**AGENDA
CITY OF CEDAR FALLS, IOWA
PLANNING AND ZONING COMMISSION MEETING
WEDNESDAY, OCTOBER 09, 2024
5:30 PM AT CITY HALL, 220 CLAY STREET**

TO: Planning and Zoning Commission
FROM: Chris Sevy, AICP, Planner II
DATE: October 9, 2024
SUBJECT: Request to vacate a 5-foot easement on property at 1907 Valley High Drive

TO: Planning and Zoning Commission
FROM: Jaydevsinh (JD) Atodaria, AICP, Planner II
DATE: October 3, 2024
SUBJECT: PC-2 District Site Plan – 924 W. Viking Road (SP24-010x)

SUBJECT: RP District Master Plan Amendment and Site Plan – Cedar Falls Bible Conference

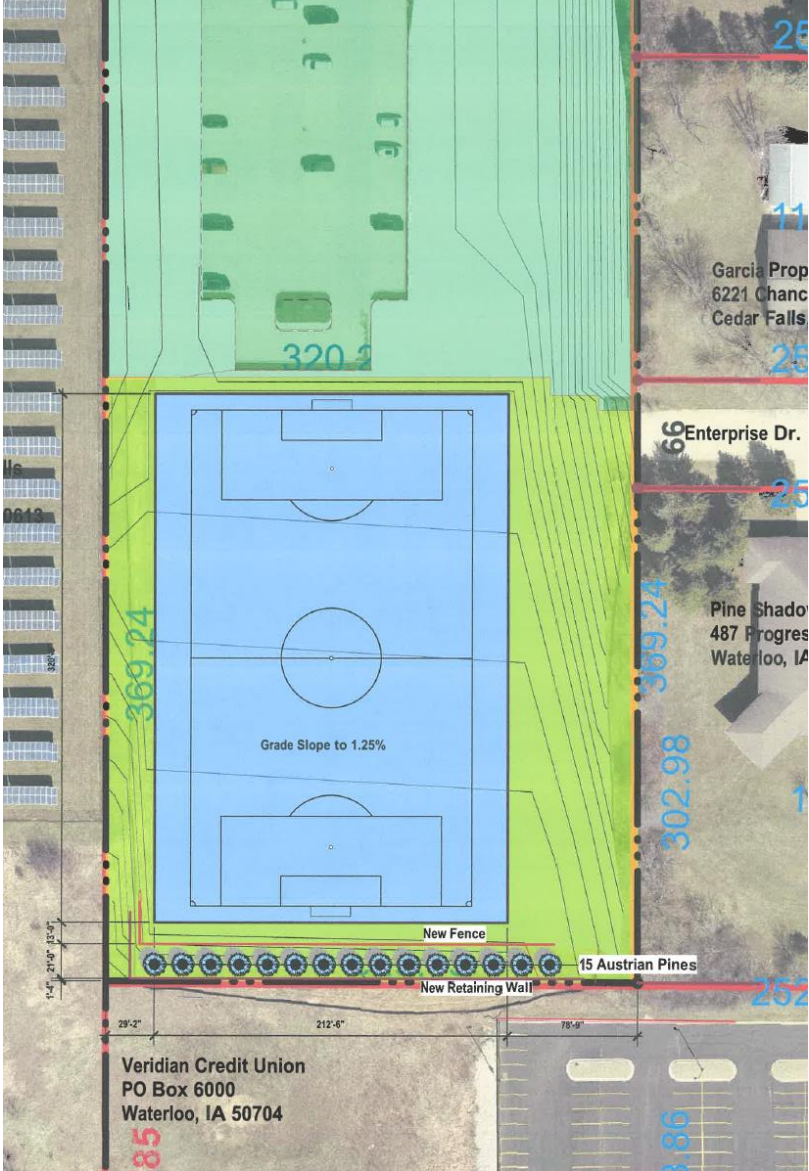
After indicating that no retaining wall would be needed with the previous application, the applicant found that during construction there was not enough room to create a gradual slope around the soccer field, so they constructed an approximately 9 ft. high retaining wall on the south side of the practice soccer field. The applicant is requesting to keep the tall retaining wall and have indicated the improvements necessary to bring the site into compliance with Building Code safety standards. (See image to the right for location reference)

To meet Building Code safety standards, a minimum 42-inch guardrail/fence is required along the top of the wall (as shown in the image to the right), which will be placed approximately 21 feet north of the retaining wall. In addition, the applicant is proposing to add 15 Austrian Pine trees between the fence and the retaining wall to create a more substantial buffer. The applicant has also noted that they plan to include additional netting along the south side of the soccer field to keep soccer balls from going over the retaining wall.

Staff recommends approval of an amendment to the previously approved PC-2 site plan for a soccer field located at 924 W. Viking Road to allow an already constructed retaining wall to remain and a minimum 42-inch guardrail fence and landscape buffer to bring the site into compliance with Building Code safety standards, subject to any comments or direction specified by the Planning and Zoning Commission.

924 Viking Rd - Revised Master Plan

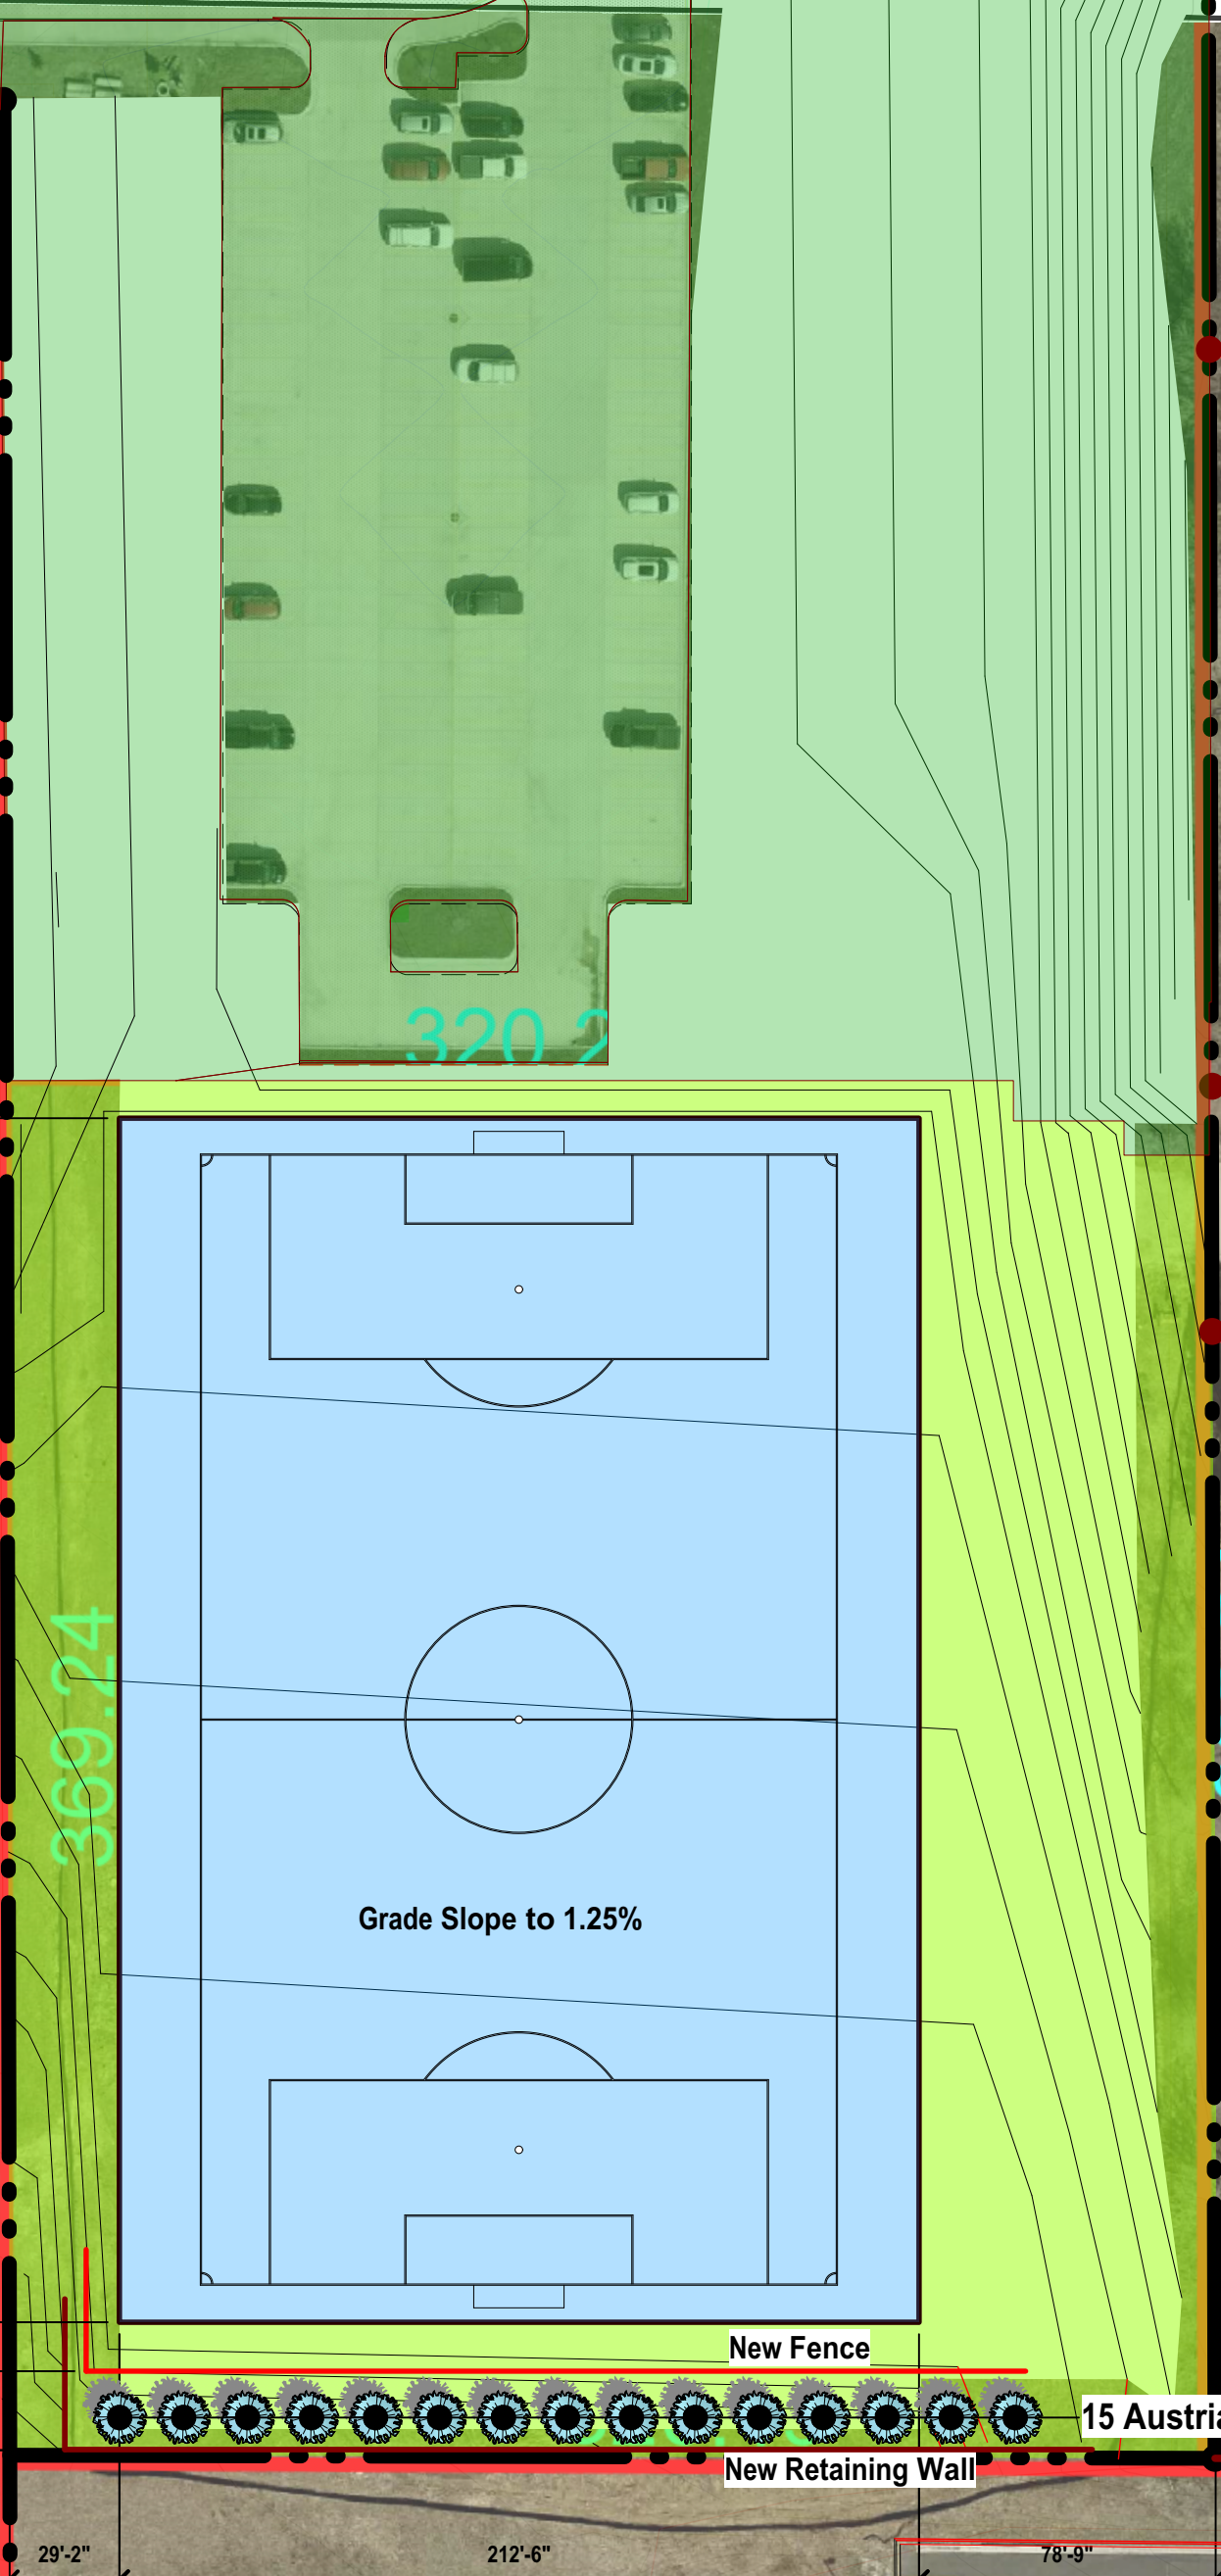
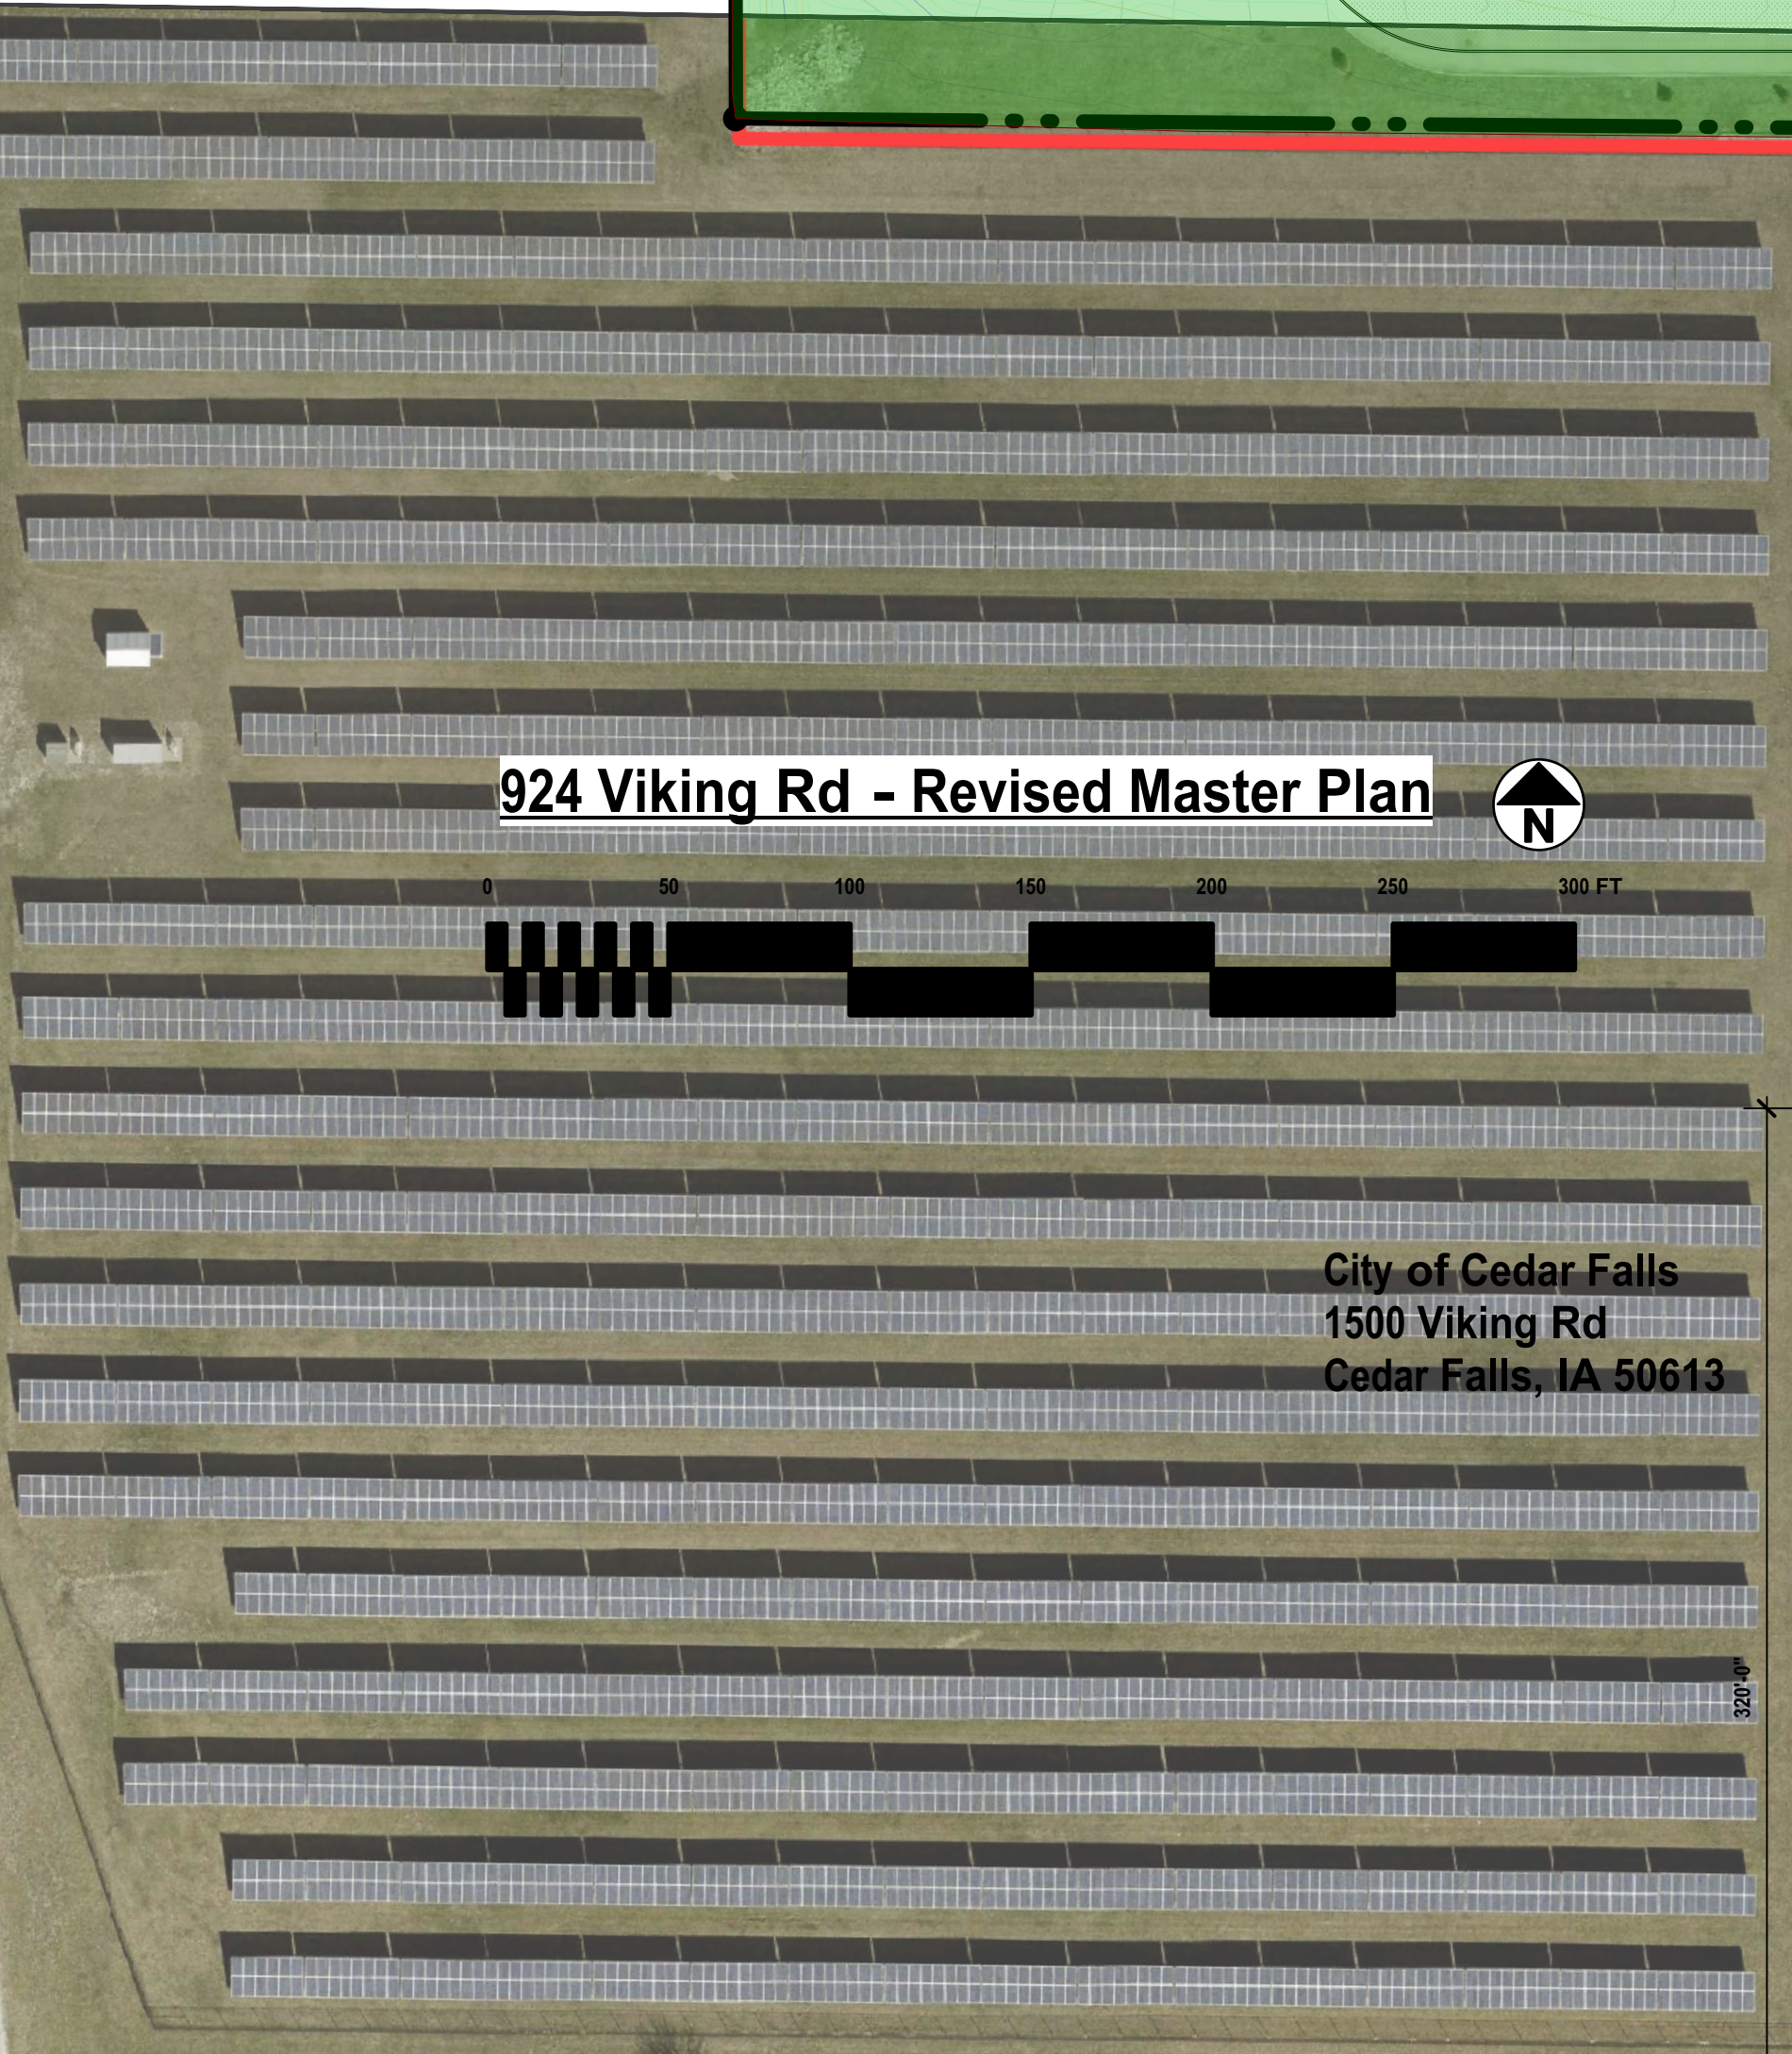
Previous master plan showed only the area needed for a soccer field and did not address the grade changes at all.
